**Economic Commission for Europe****Inland Transport Committee****World Forum for Harmonization of Vehicle Regulations****159<sup>th</sup> session**

**1958 Agreement – Consideration of draft amendments  
to existing Regulations submitted by GRE****Proposal for Supplement 2 to the 06 series of amendments to  
Regulation No. 48 (Installation of lighting and light-signalling  
devices)****Submitted by the Working Party on Lighting and Light Signalling\***

Figure (see paragraph 6.5.)

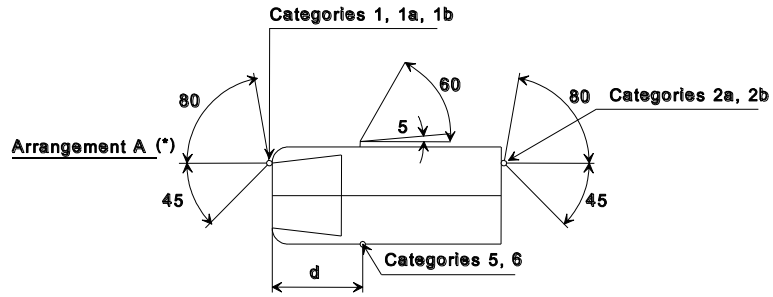
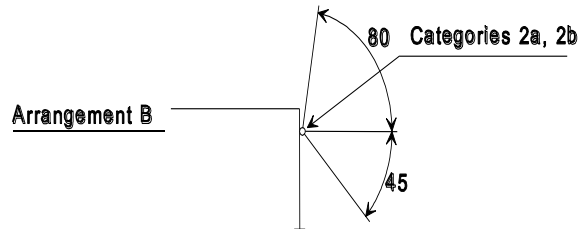
*Paragraphs 6.5.5. to 6.5.5.2., including the figures,* amend to read:

6.5.5.1. Horizontal angles: (see figure below)

Vertical angles:  $15^\circ$  above and below the horizontal for direction indicator lamps of categories 1, 1a, 1b, 2a, 2b and 5.

- (a) Where a lamp is mounted below 750 mm (measured according to the provisions of paragraph 5.8.1), the downward angle of  $15^\circ$  may be reduced to  $5^\circ$ ;
- (b) Where an optional rear lamp is mounted above 2,100 mm (measured according to the provisions of paragraph 5.8.1) the upward angle of  $15^\circ$  may be reduced to  $5^\circ$ .

$30^\circ$  above and  $5^\circ$  below the horizontal for direction indicator lamps of category 6.

(\*) The value of 5° given for dead angle of visibility to the rear of the side direction-indicator is an upper limit  $d \leq 1.80$  m (for  $M_1$  and  $N_1$  category vehicles  $d \leq 2.50$  m).

For the direction indicator lamps of categories 1, 1a, or 1b, 2a and 2b mounted below 750 mm (measured according to the provisions of paragraph 5.8.1), the inward angle of 45° may be reduced to 20° under the H plane.

6.5.5.2. Or, at the discretion of the manufacturer, for  $M_1$  and  $N_1$  category vehicles: Front and rear direction indicator lamps, as well as side-marker lamps (\*\*).

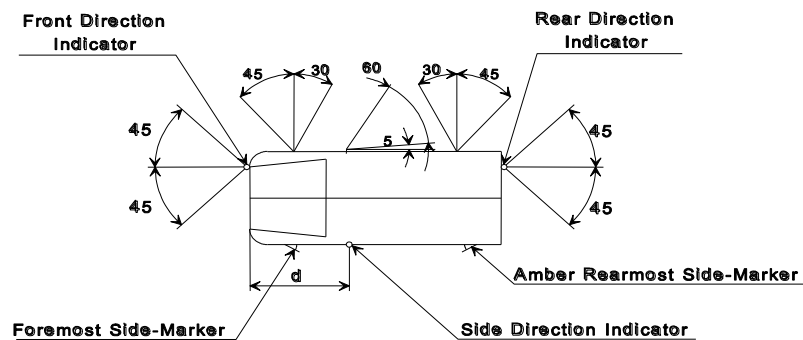
Horizontal angles: (see figure below)

(\*\*) The value of 5° given for the dead angle of visibility to the rear of the side direction-indicator is an upper limit.  $d \leq 2.50$  m

However, for the direction indicator lamps of categories 1, 1a, or 1b, 2a and 2b mounted below 750 mm (measured according to the provisions of paragraph 5.8.1), the inward angle of 45° may be reduced to 20° under the H plane.

Vertical angles: 15° above and below the horizontal. However, where a lamp is mounted below 750 mm (measured according to the provisions of paragraph 5.8.1), the downward angle of 15° may be reduced to 5°.

To be considered visible, the lamp must provide an unobstructed view of the apparent surface of at least 12.5 square centimetres, except for side direction-indicators of categories 5 and 6. The illuminating surface area of any retro-reflector that does not transmit light shall be excluded."
